Comment No.	Comment	Response
	<p> FELSBURG HOLT & ULLEVIG Figure 3 Teton County Alternative <small>WY89 EIS 06-140 08/23/06</small> </p>

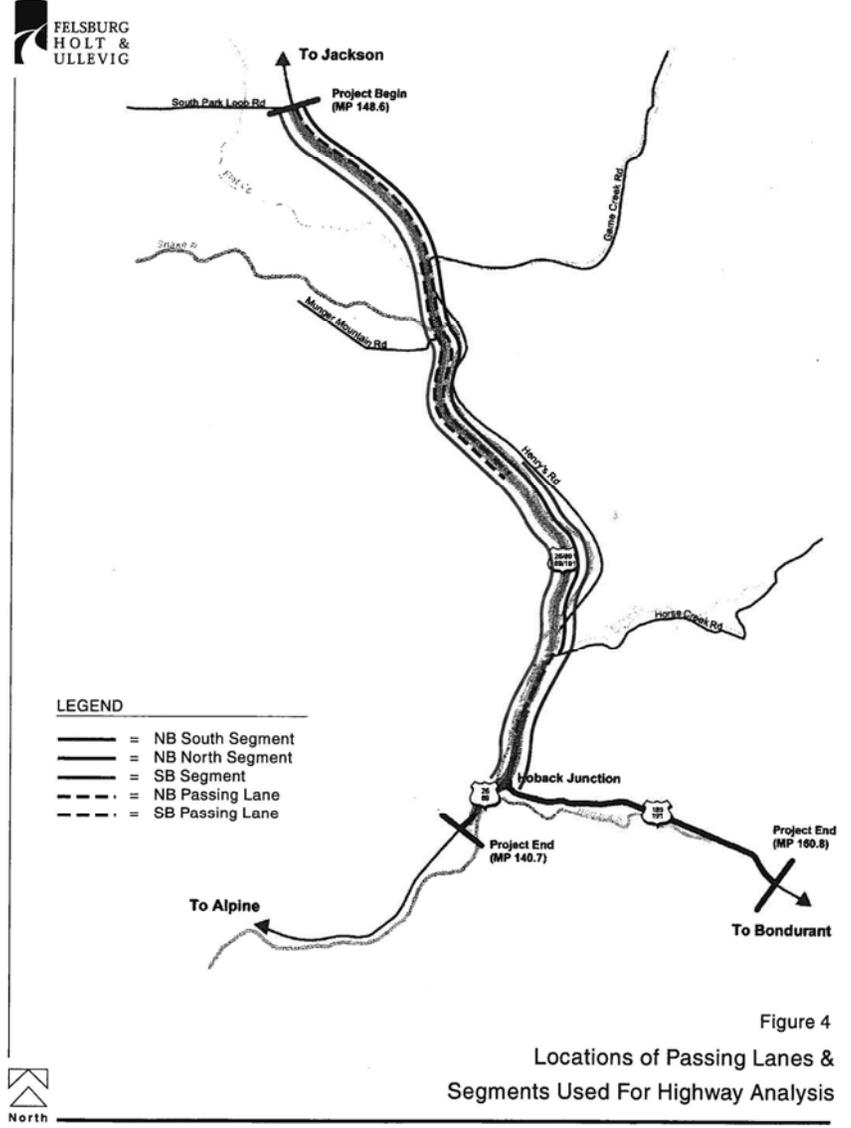
Comment No.	Comment	Response																																										
	<p>August 29, 2006 Memorandum to Ms. Paula Stevens Page 5</p> <p>As the figure indicates, the alternative would provide one southbound and two northbound lanes plus left turn lanes at each intersection from the end of the current five lane section to Game Creek Road, two lanes in each direction from Game Creek Road to the south side of the first Snake River Bridge (no left turn lanes would provided because only three low volume access points are located along this section), two lanes in each direction plus a center two way left turn lane from the bridge to just north of the Ross Gravel Pit Road, one lane in each direction plus a center two way left turn lane from there to just south of Horse Creek Road, and the Preferred Alternative three lane cross section from there through Hoback Junction (two northbound lanes and one southbound lane north of Hoback Junction, and one lane in each direction plus a center two way left turn lane through Hoback Junction to the intersection with WY 189).</p> <p>ANALYSIS</p> <p>Level of Service</p> <p>The methodologies outlined in <u>Chapter 20 - Two Lane Highways</u> of the <i>Highway Capacity Manual</i> (HCM), were used to analyze the Teton County alternative for WY 89. The analysis examines levels of service in each direction of a two lane facility, and includes adjustments to account for the presence of passing lanes. To properly account for these adjustments, the northbound analysis was broken into two segments, one extending from Hoback Junction to Ross Gravel Pit Road to analyze the southernmost passing lane, the other from Horse Creek Road to South Park Road to analyze the northernmost passing lane. The two segments overlap by approximately one mile because each was selected to cover the entire two lane section before and after the passing lane in order to capture the vehicle interaction prior to the lane (where the most vehicle platooning would occur) and after the lane (where platooning is initially minimized but increases as the road approaches the next passing lane). The southbound direction was analyzed as one segment because it consists of only one passing lane. Figure 4 shows the locations of the passing lanes, as well as the segments used in the analysis.</p> <p>The traffic volumes used in the analysis were taken from the 2026 traffic forecasts in the EIS. Because the EIS developed forecasts for five segments (Table 1) that did not match up with the passing lane segments, the analysis selected volumes that were representative of the traffic conditions in the middle of the passing lane segment (Table 2).</p> <p>Table 1. 2026 EIS Traffic Forecasts</p>
